SERVICE BULLETIN

Subject: MDT2 B Series

The MDT2C12A-1A has been replaced by MDT2C12A-1B.

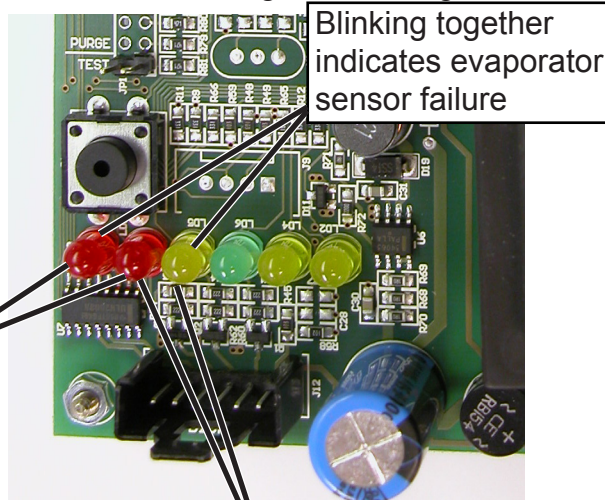
The reason for the B series are several component changes. The significant changes are the controller, sensors and compressor, which are **not interchangeable** with the A series parts. The new part numbers are:

Compressor F670100-03, Start Relay FCUB405182, Start Capacitor, FEMB2252217

Controller F620448-09, Water sensor wire F620519-02, Condenser sensor F620519-04, Evap sensor F620519-01.
